Flight Procedures Cover Page	Task Action: Abbreviated Amendment	Task Type: IAP	Estimated Chart Date: 03/19/2026	APWS Task ID: 1BAA4C82D86844CD92D2D042FE48D248	APWS Project ID: F54EAA41A97F4603A2F2D5AB8B331E64
Procedure: RNAV (GPS) RWY 32 AMDT 0A		Enroute: NO	Specialist: Smith, Bryant		Agreement Number:
Airport ID: 07A			Airport City: UNION SPRINGS		State: AL
Facility ID:	Facility Type:	Flight Inspection Remark Type:

RNAV (GPS) RWY 32
FRANKLIN FLD (Ø7A)

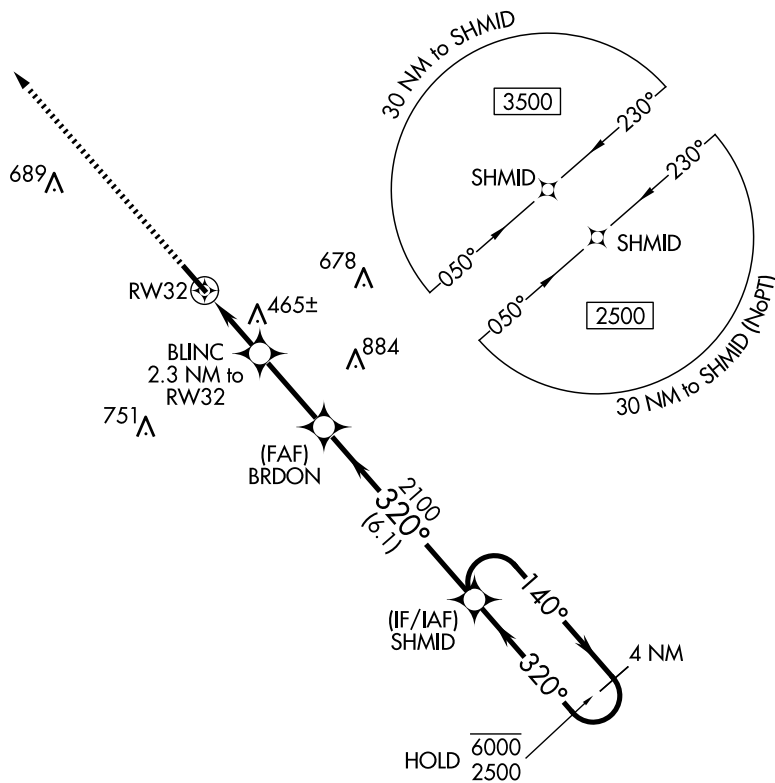
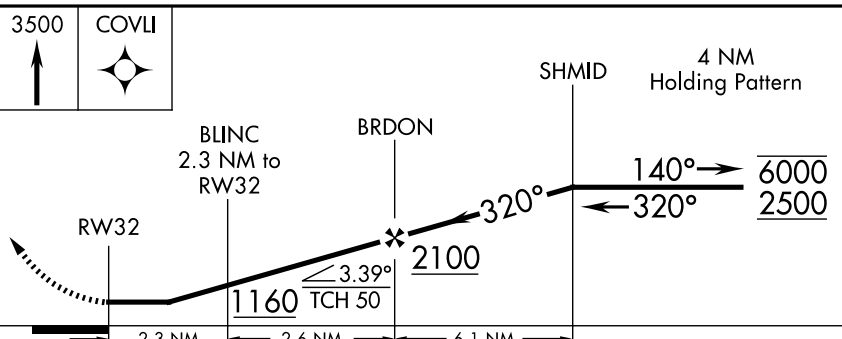
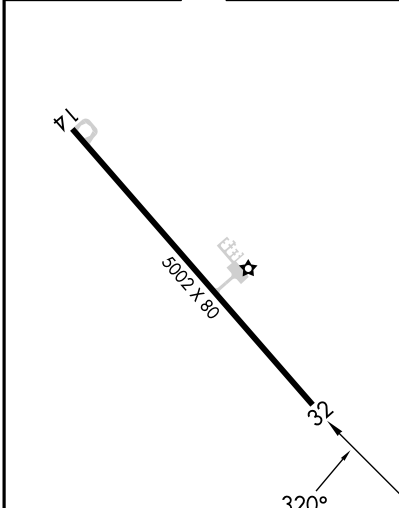
!FDC 4/1558 07A IAP FRANKLIN FLD, UNION SPRINGS, AL. RNAV (GPS) RWY 32, ORIG... DELETE: DESCENT ANGLE 3.39/TCH 50. PROFILE NOTE: VISUAL SEGMENT - OBSTACLES. 2410211253-2610211253EST
